# PCB Design Review

PCB as received from PCB Engineer

### Placement and wiring of Power Switch components

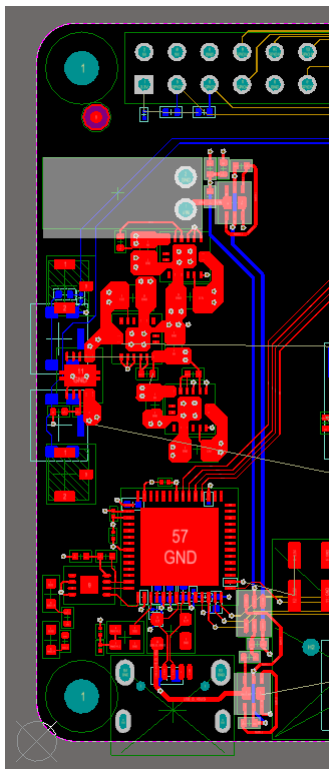
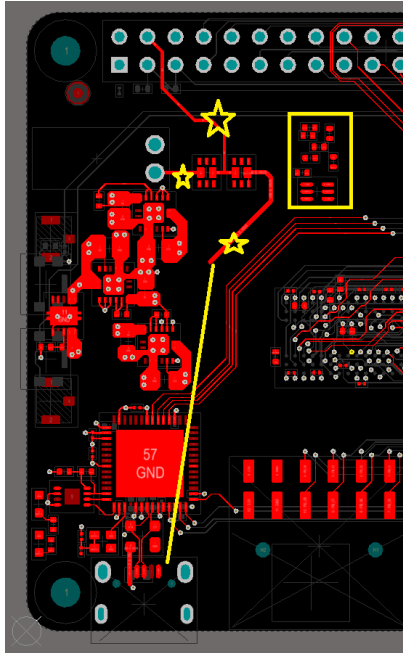
Those components build a simple 2 to 1 Power select switch, two inputs and one output.

This is how the components are placed, notice the blue bottom side POWER traces!

This is pre-placement for the two power switches, all wires carrying power are marked with yellow. In the yellow box are additional components that do not carry any current and are not as important as of placement and routing.

## Issue #2

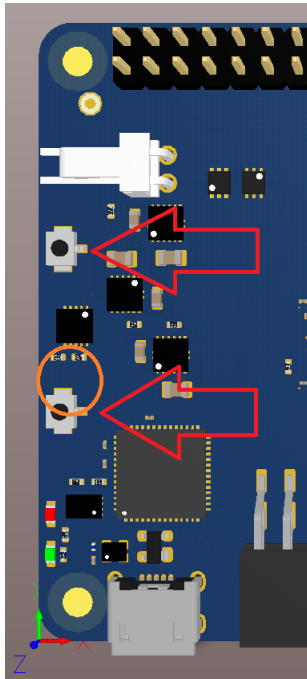
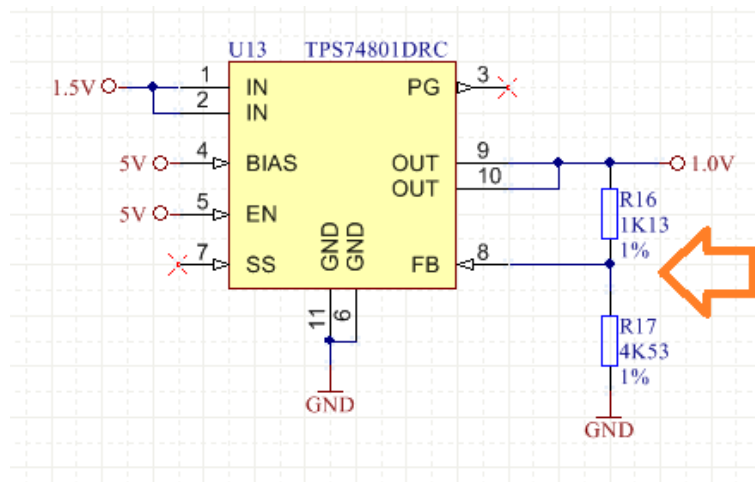
Placement of components too close to user interface – there are two push-buttons, where it would be better to have more clearance so the fingertips would not touch any electronic components.

Marked with orange is “fingertip” pressing the button and touching LDO feedback resistors!

This is where you would touch the feedback pin of the LDO, the most sensitive pin that can cause the output voltage to change and potentially damage some more components.

There was no need to place the LDO that close to the buttons!

#### Placement of 1.0V LDO

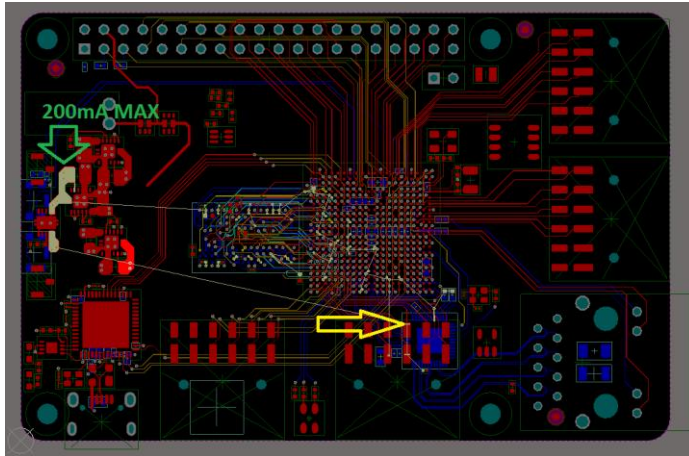
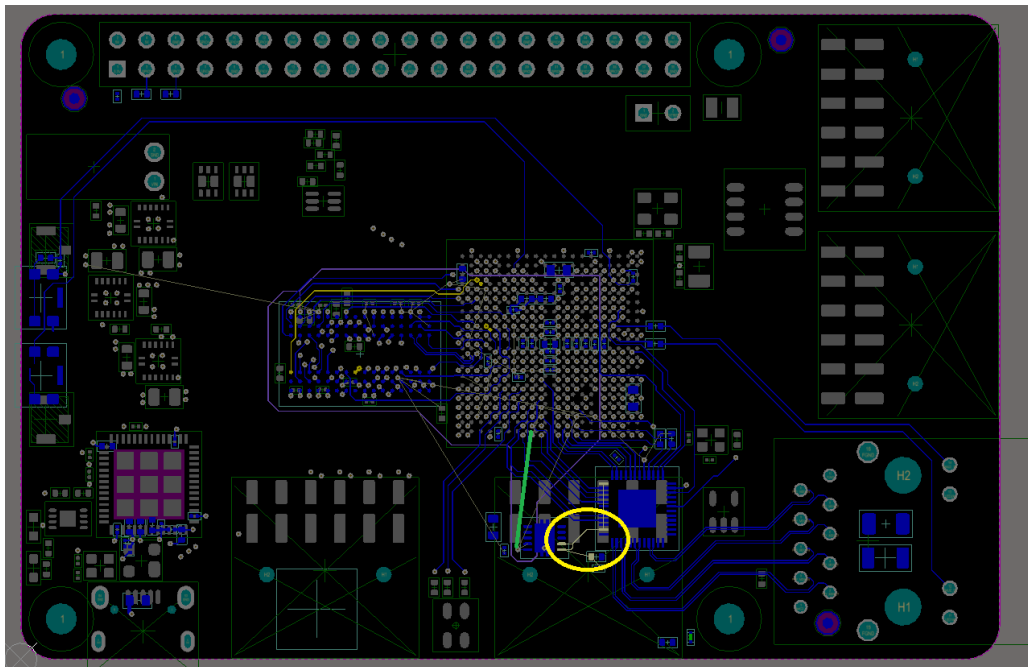
Yellow marks where the Ethernet PHY needs the 1.0V that is powering also sensitive analog circuits, so placing the LDO closer would be also better as of noise coupling. Green marks where the PCB designed did draw a POLYREGION for power signals that can carry maximum of 200mA (typical 95mA). There is no need for polygons for power nets that do not carry significant currents.

Changed Placement: the LDO is placed to the current consumer Ethernet PHY (1.0V connections inside the yellow marking). Green marks the additional current path from 1.5V polygon below the main IC in the middle of the PCB to the input of the LDO.

#### Issue #4

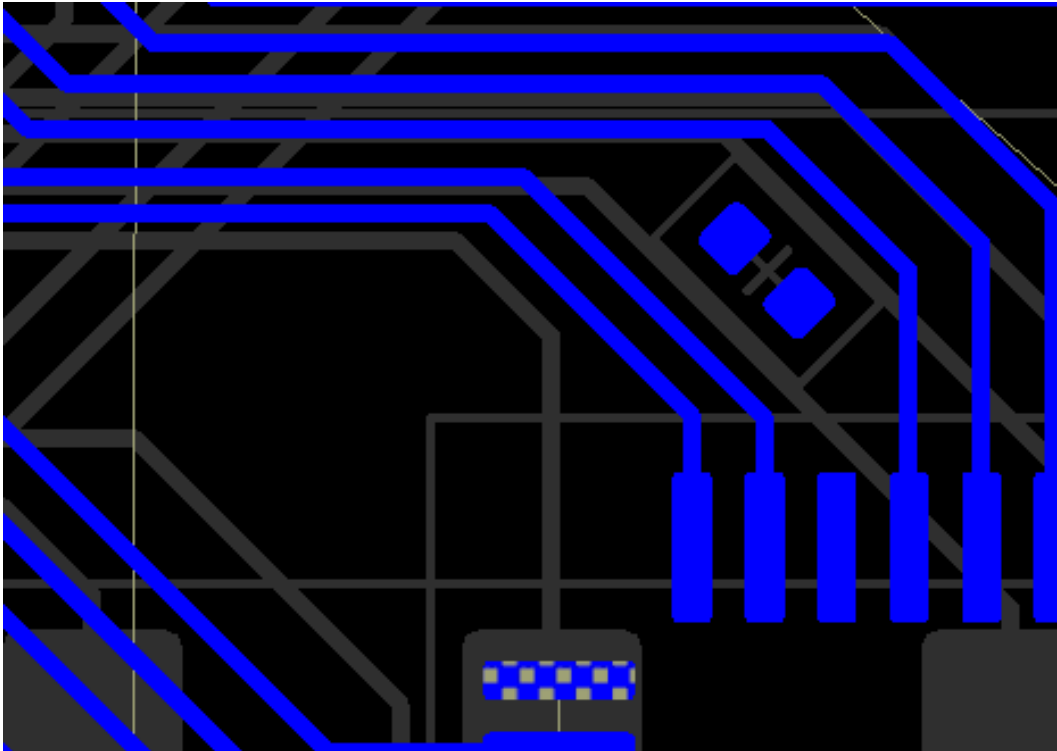
Rotation 45 degrees!?

Only one single component has been rotated by 45 degrees. While assembly at 45 or any other angle is possible it should really if avoided if not really needed.

## Issue #5

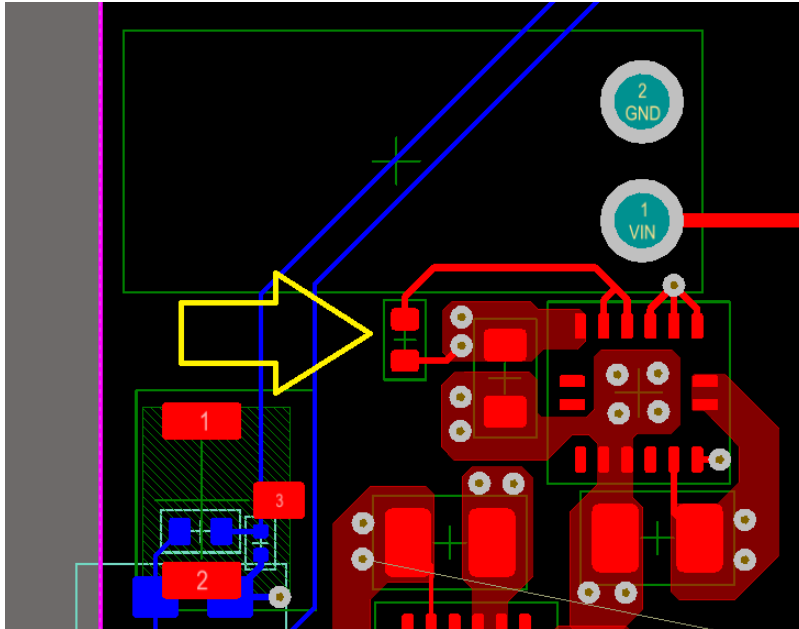
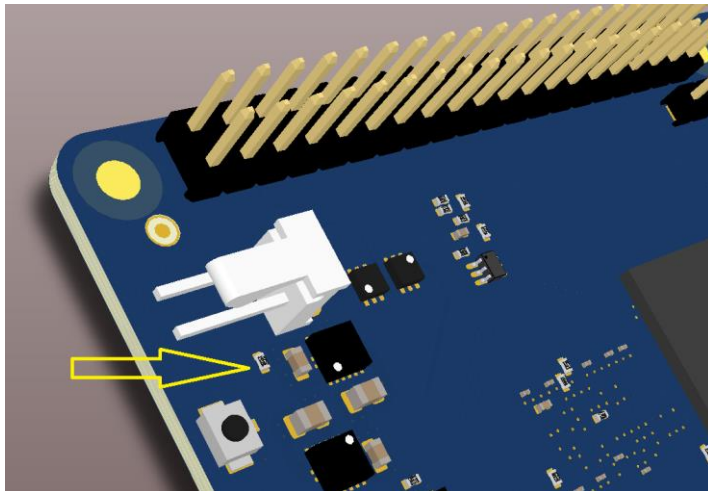
SMD component too close to connector, potential damage when inserting cable/connector.

Component by arrow is moved to not collide with connector courtyard, so it looks like legal placement.

This is how it looks in 3D View, it is clear that there is a danger that connector when plugged in could damage the resistor! And there is absolutely no need to place that resistor so close to the connector.

## AVIN routing issue #1

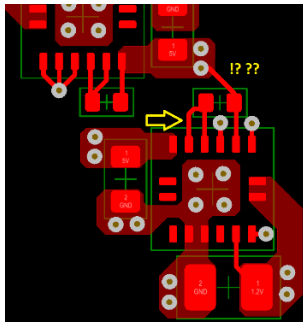
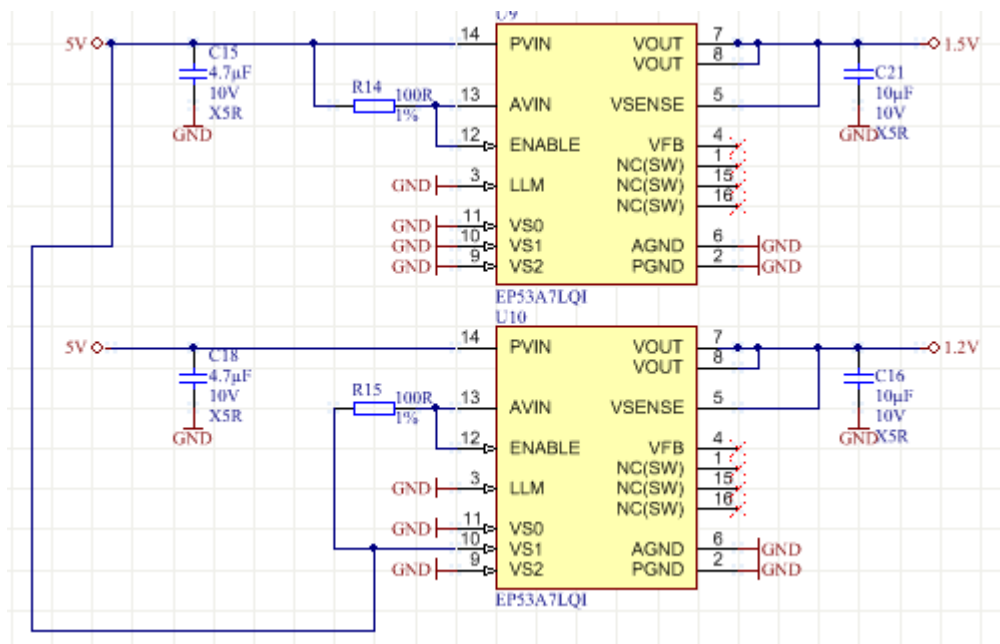
Marked yellow is AVIN input that as per recommendation has to be connected to VIN at Quiet point as visible in the recommended layout. The PCB designer however connected the AVIN first to VID1 and then to VIN of different DCDC converter!

This is how his work would be in “back annotated” schematic:

### AVIN routing issue #2

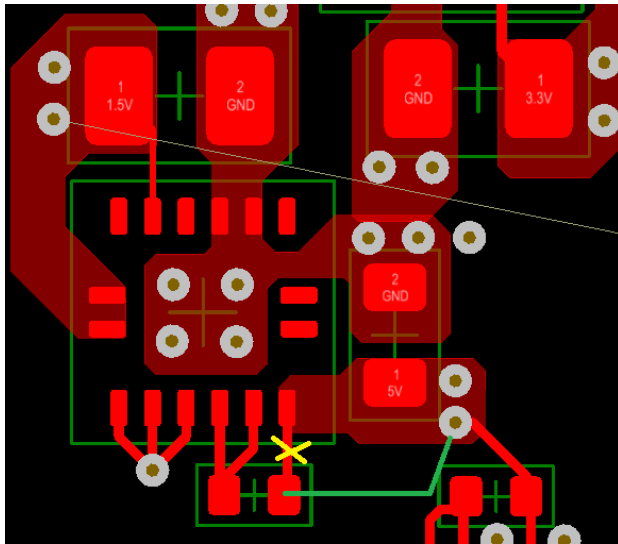
AVIN routing at second DCDC also incorrect, marked green is where the AVIN connection should be.

Third DCDC AVIN connection looks correct, but this is not because PCB engineer did know what or why he is doing, no he had to move the AVIN resistor to correct place because there was a connector that did not allow it to be at wrong place! So it was co-incidence that one AVIN from DCDC was wired correctly.

## Issue #8

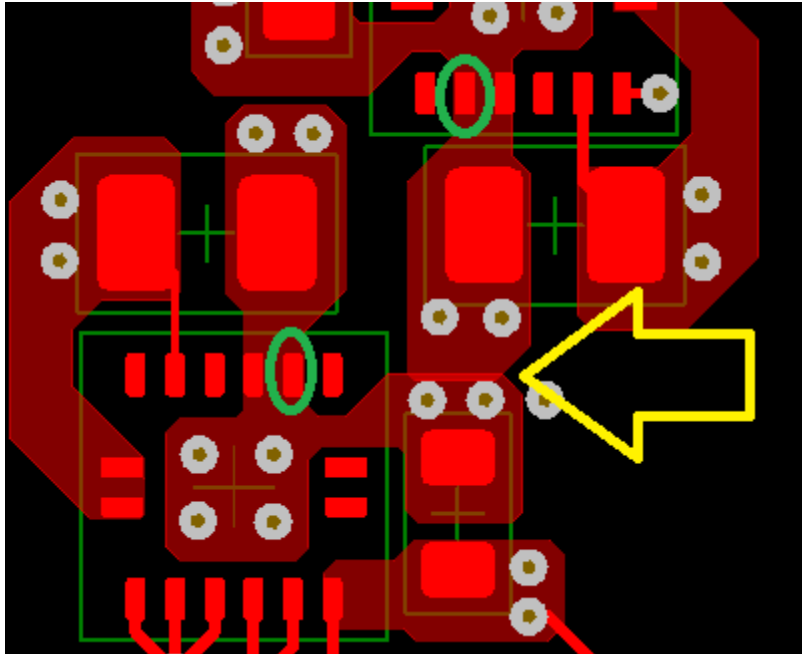
Incorrect GND connection

GND of VIN Capacitor from one DCDC is with direct top layer copper connected to GND point of VOUT capacitor of another DCDC. In datasheet: Input and output grounds should only connect at PGND pin (marked green).

### Differential routing

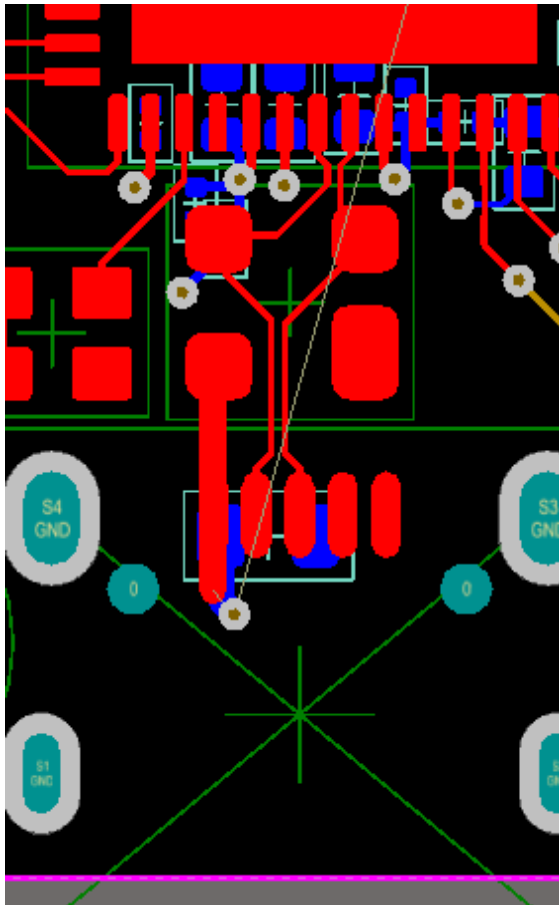
This looks nasty, could be improved.

## Issue #10

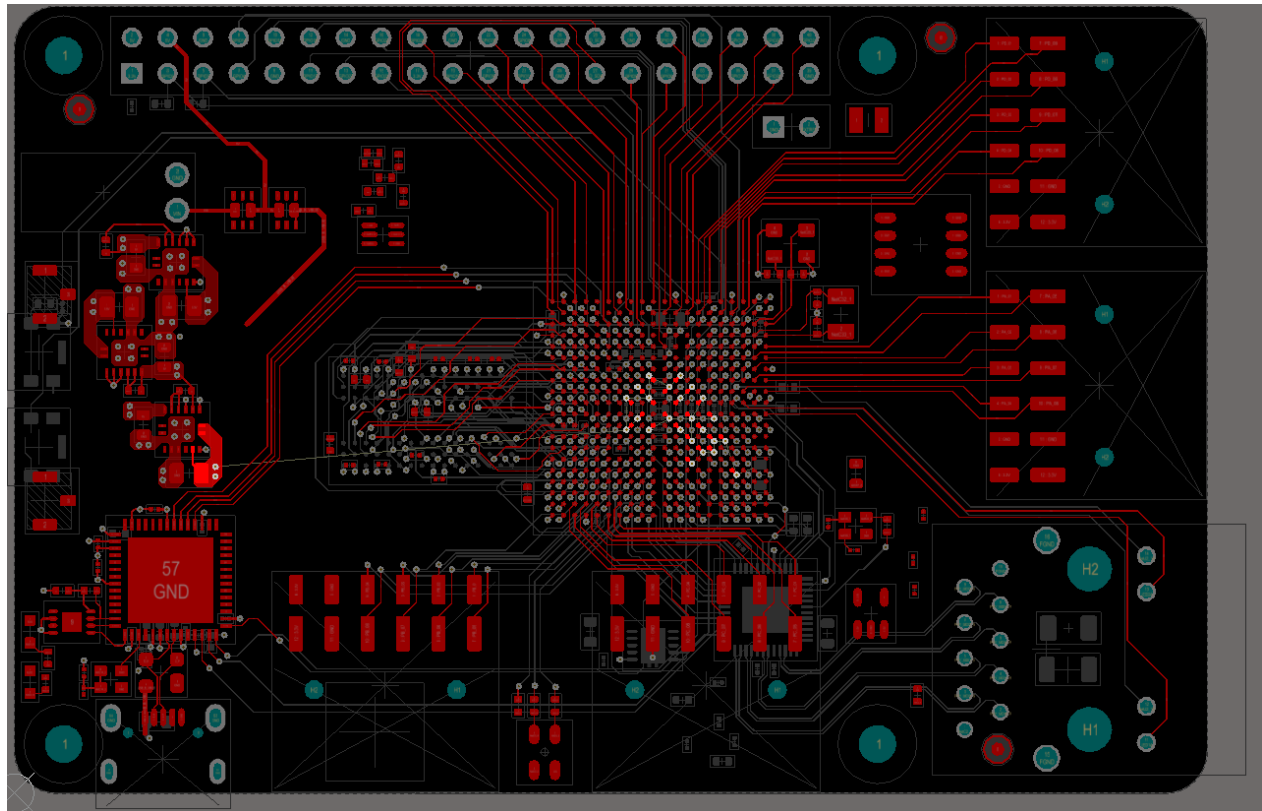
Bad placement for FPGA Core Voltage DCDC regulator.

DCDC Regulator could be placed much closer to where the current is needed, as is the 1.2V core supply current must go all the way below DDR3 memory to reach the middle of the FPGA BGA Package.

## Issue #11

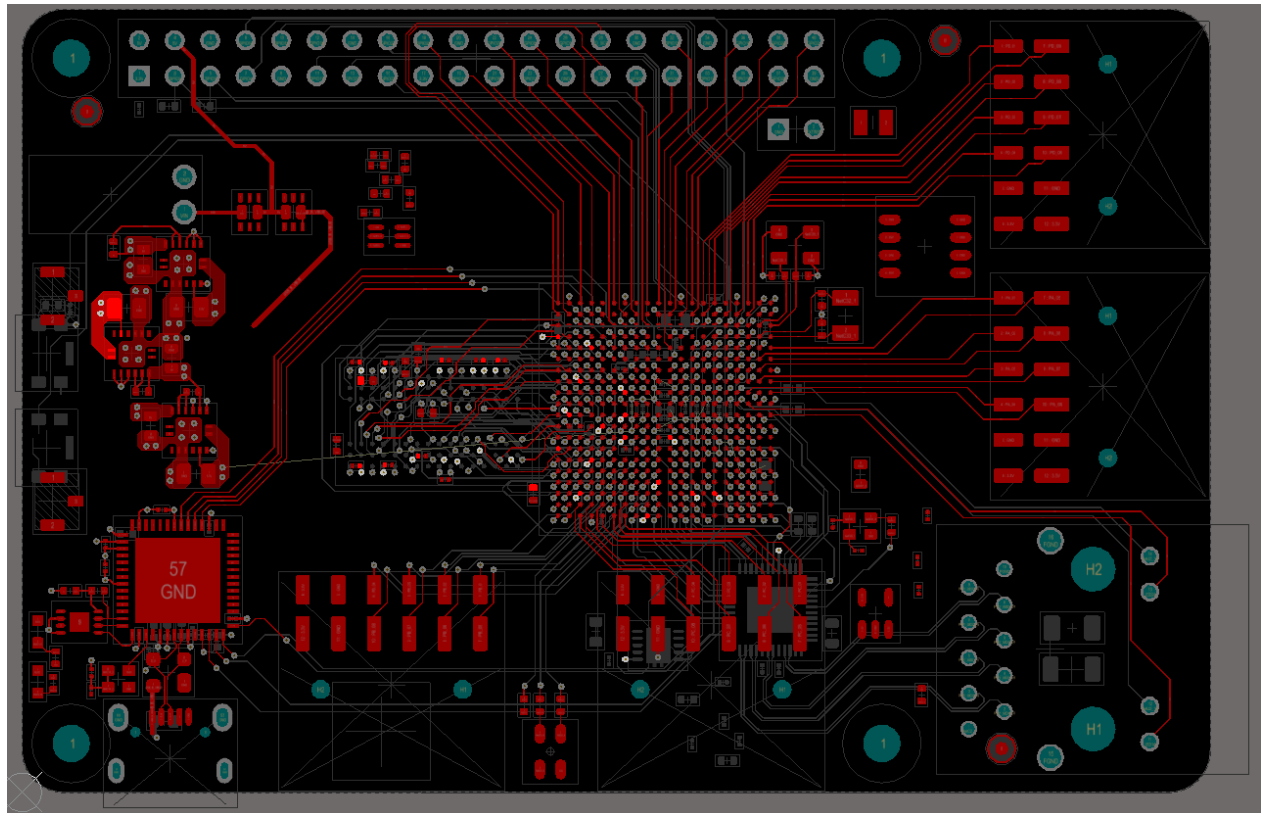
Bad placement of 1.5V DCDC Regulator

## Issue #12

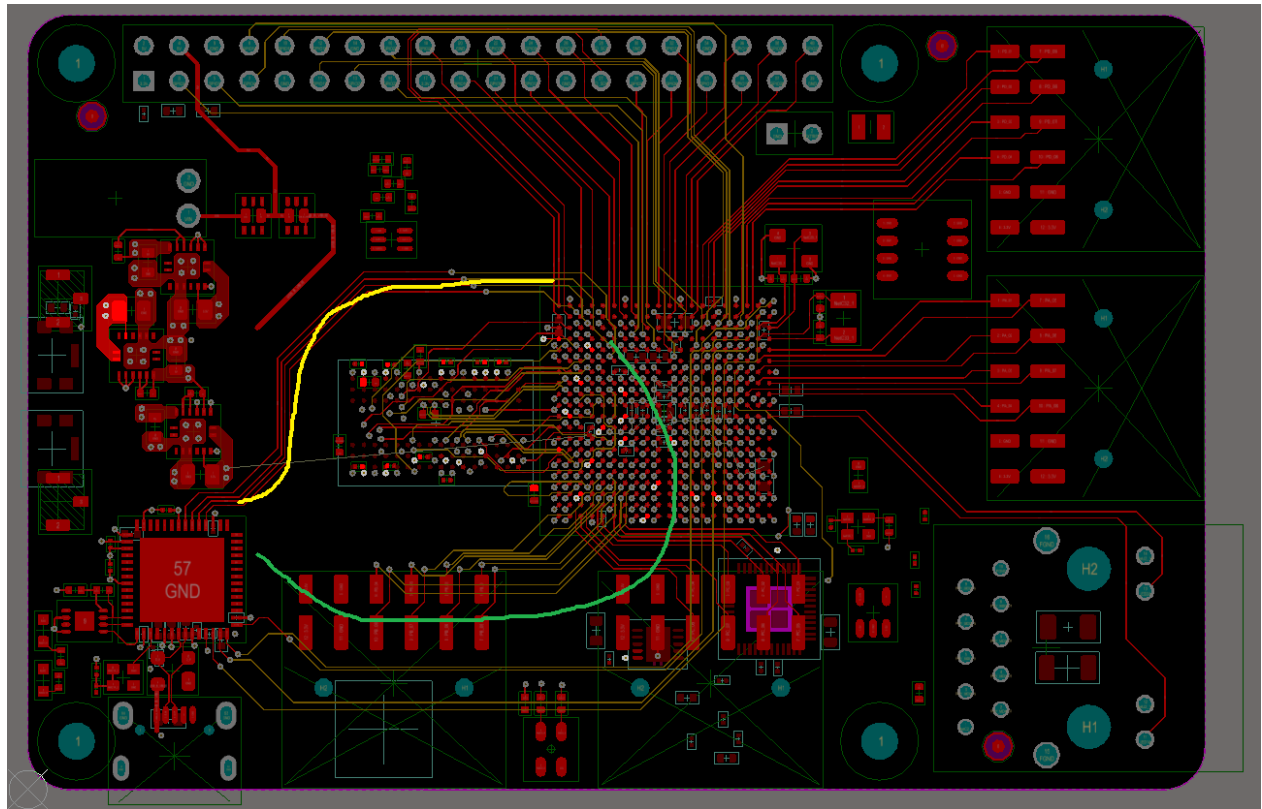
Routing priority, minor

Marked yellow are traces from PCB engineer, marked green are same traces in inner layer, leaving all the routing resources and TOP layer placement around the yellow line free.

Issue #13  
Placement/routing

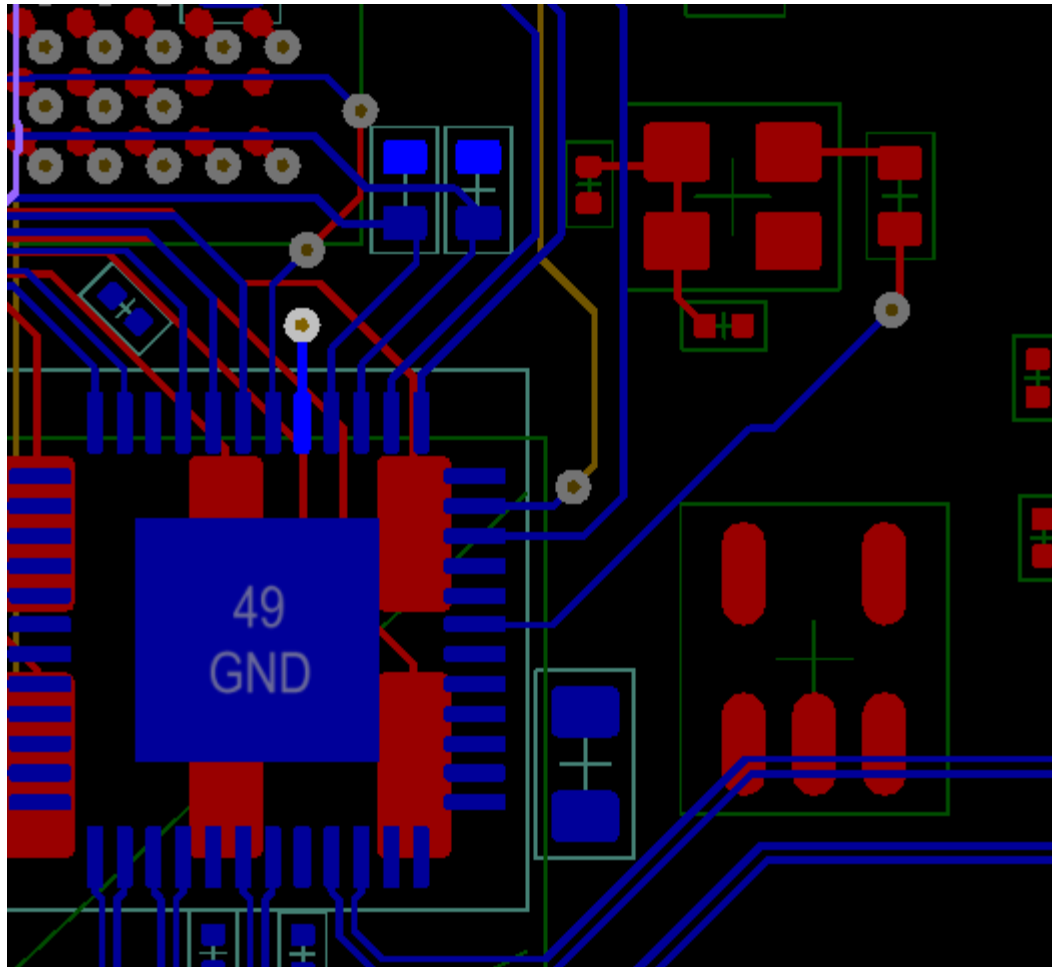
Oscillator (the IC with 4 PADs in the top right corner) could be placed in the bottom layer
